**Subject: Notification of Planned Change to the Permitted Facility Regarding the
Excavation and Construction of Shaft and Associated Drifts, Hazardous Waste
Facility Permit, Number: NM4890139088-TSDF**

New Shaft and Connecting Drifts
(Conceptual Drawings Only)

Figure 1: Proposed Surface Location of New Shaft

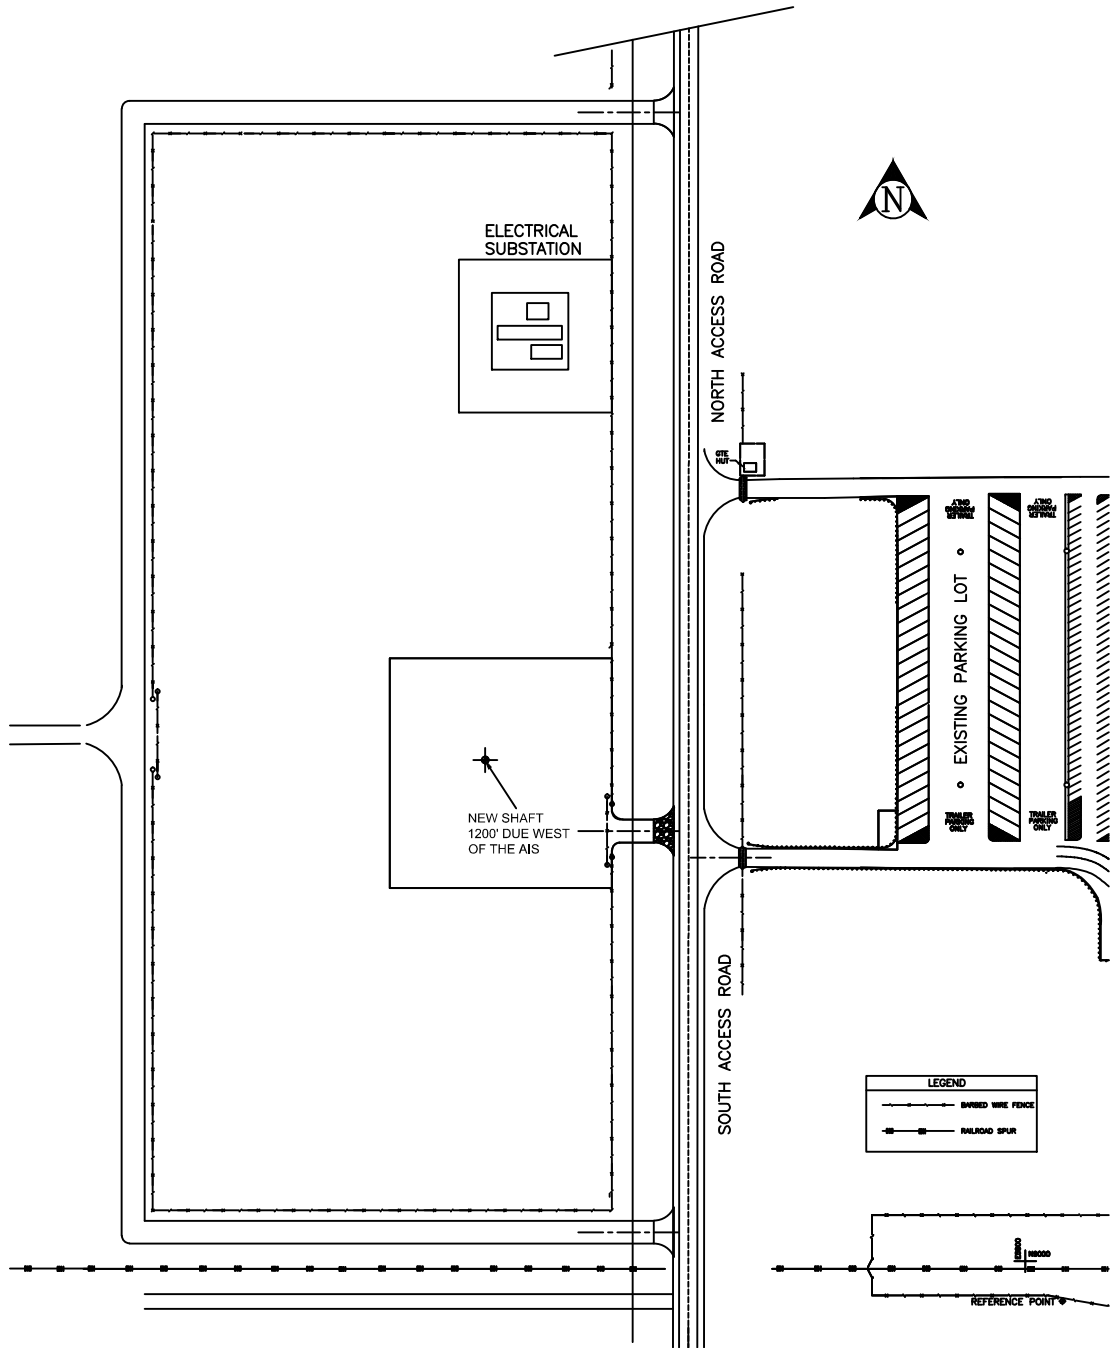
Shaft Number 5 will be located approximately 1,200 feet west of the existing AIS. Surface-mounted fans are planned to be used to downcast air into the underground via S#5. The air from the S#5 will primarily be used to ventilate the Construction and Disposal Circuits through the new connecting drifts. Exhaust air from the North Disposal and Waste Shaft Station Circuits are planned to be exhausted through the existing Exhaust Shaft. Exhaust air from the Construction Circuit is planned to be routed through the existing AIS. The enclosed document provides the conceptual drawings of S#5 and associated facilities.

Figure 2: Proposed Underground Location of New Shaft and Connecting Drifts

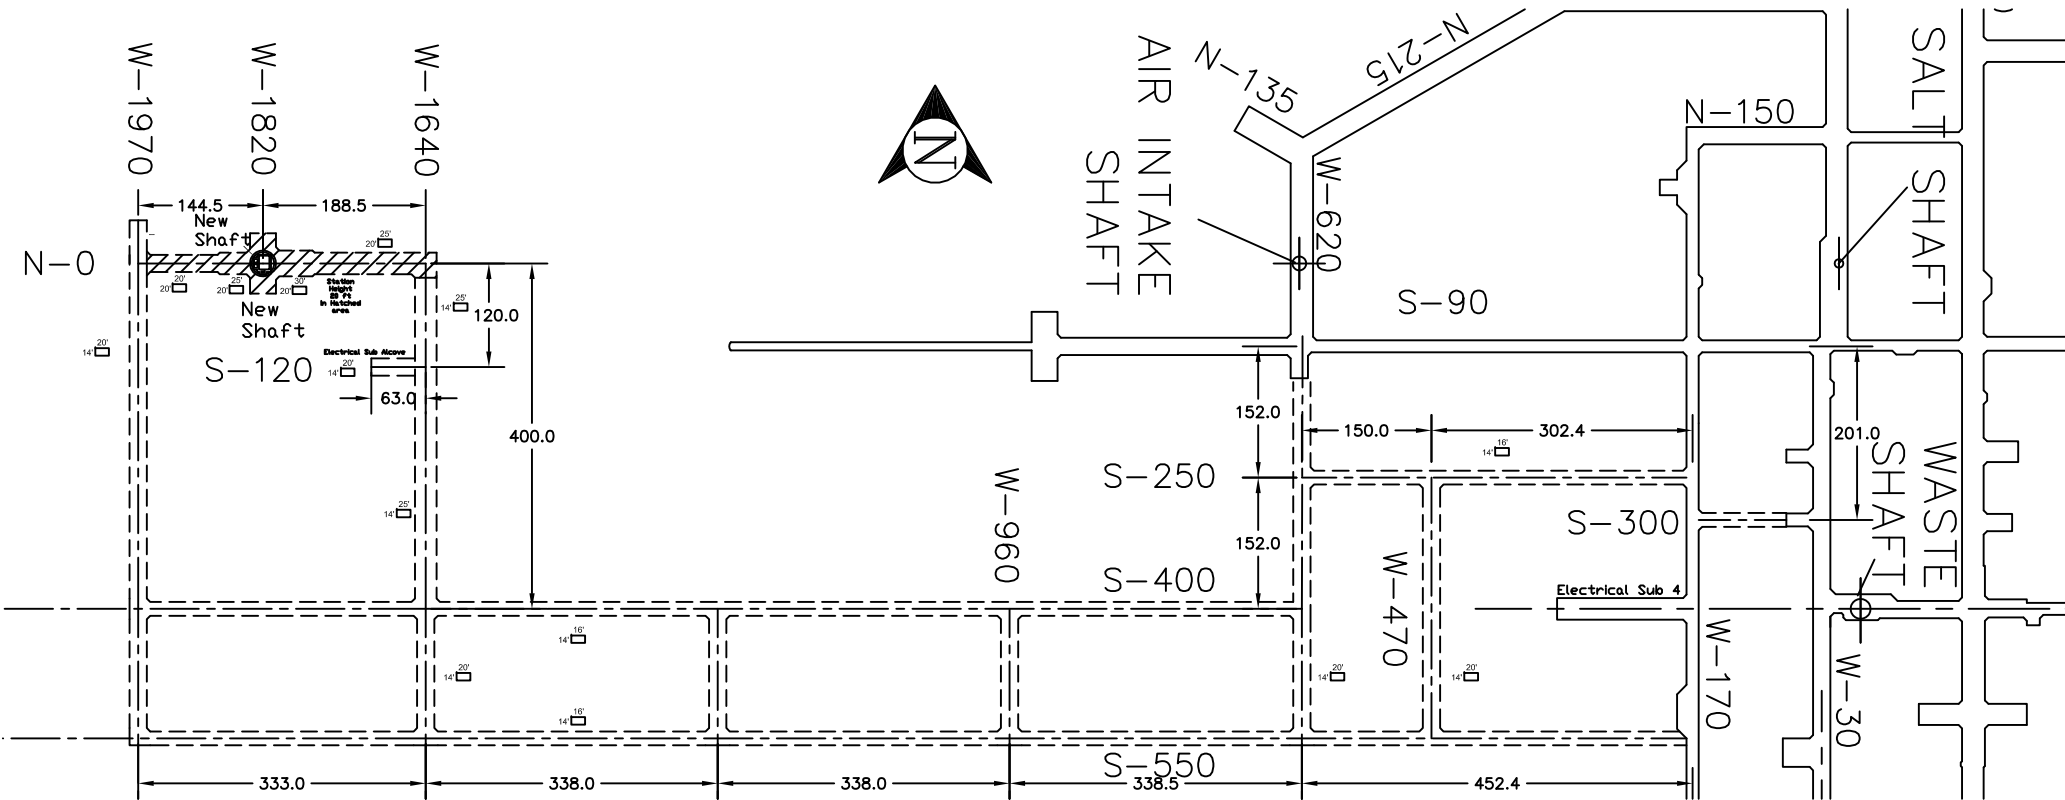
PROPOSED DRIFTS TO CONNECT THE NEW SHAFT TO THE REPOSITORY
